Re: **Response to Submissions**
Application No.: **4972-2011**
Property: **161 Sussex Street, Sydney**

Proposal: **Proposed Extension to the Four Points Hotel**

Approximate width of view corridor as seen from Level 8 of the western aspect apartments at The Berkeley

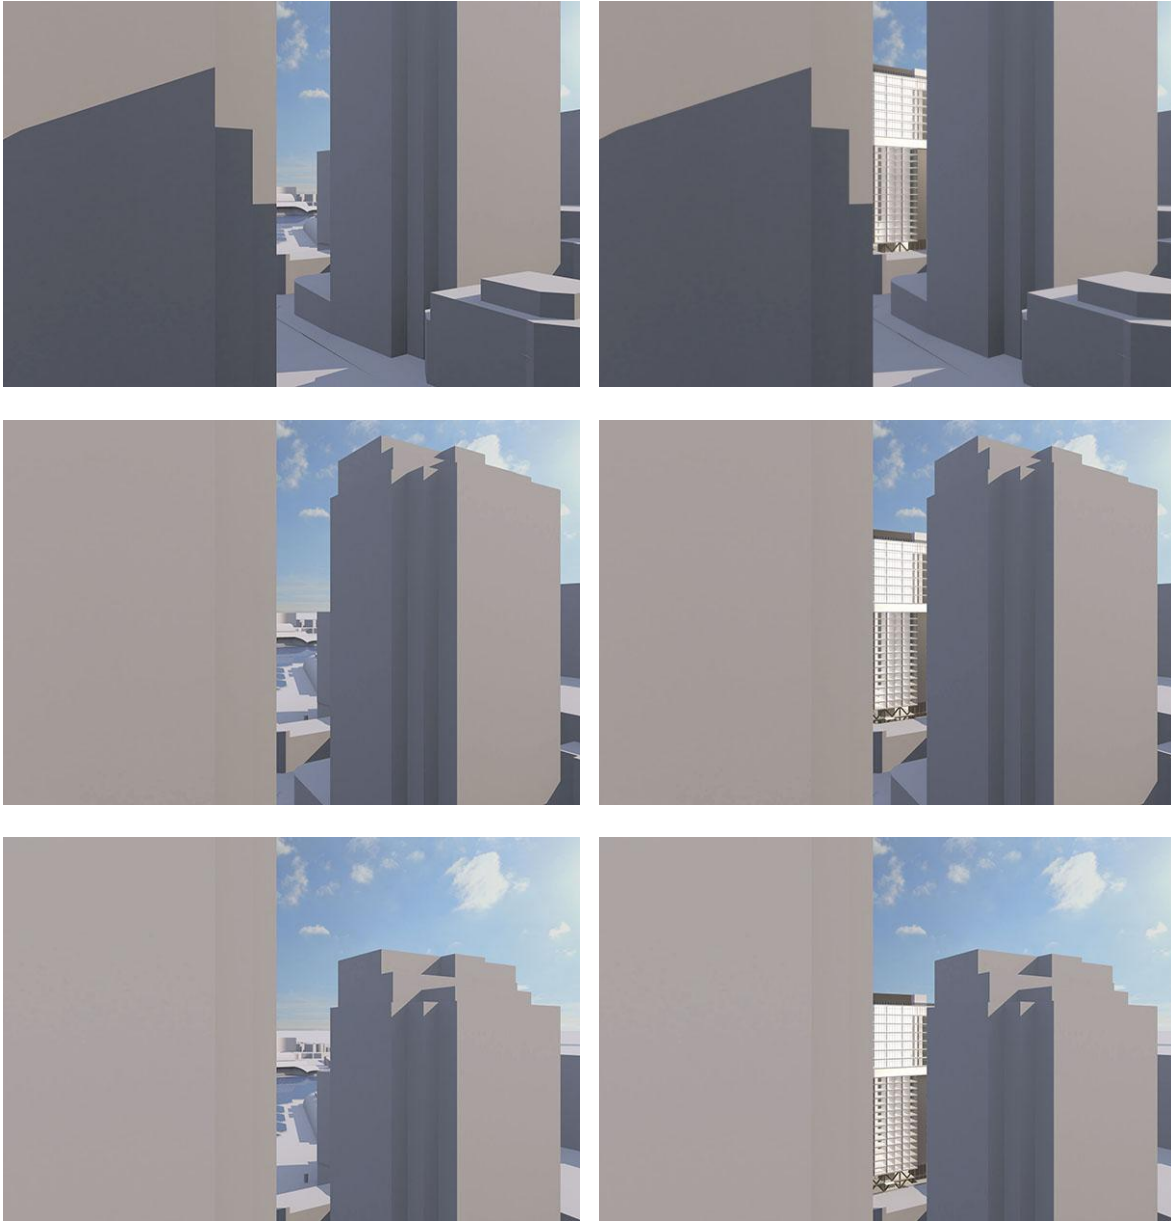
Point B of the objection raised by the residents of The Berkeley states that GMU's report "...incorrectly concludes that there is minimal loss of view, because it totally ignores the western aspect of The Berkeley, the side with the most to lose – i.e. immediate views of the harbour, iconic elements like the Australian National Maritime Museum and floating exhibits".

Views along the western façade of the building facing Kent Street were considered to be significantly constrained by the existing development of the Allianz Tower and the BT Tower. These views were considered to have a very narrow and limited view cone and to have no iconic or contextual elements within their view corridor other than small water glimpses. Site observations identified that the north-western (corner) units would have the significant view; therefore, the south-western units were not selected for further testing as part of the initial review. As part of this response to submissions, GMU has interrogated a sampling of the south-western units in question to assess their views at three different levels First Level (RL 37.88), Level 8 (RL57.13), and Level 15 (RL 76.37). The images below represent the existing views from the balcony areas as no information is available on the actual uses behind the existing windows.

Upon examination of the available views, it was determined that these are partial views of approximately 3.028m at the narrowest most critical point where the water glimpses are available. The view corridor increases marginally in width to about 4.017m toward the upper levels where areas of sky are available as seen in the image below.

Due to the narrow width of these views, the lack of iconic or contextual elements and the fact that the view is dominated by the existing massing of both the Allianz and BT towers, the view is considered to be of low-medium significance. Due to the fact that this appears to be the most significant view available to these units, it is considered a primary view and GMU recognises their importance to the residents of these units. Due to the amount of visible change within the view as shown on the 'after' montages shown below, the proposal's impact is considered to be significant. However, when analysed for the quality of the view alone, it is a highly constrained view. Its retention would preclude the Applicant's ability to redevelop the site.
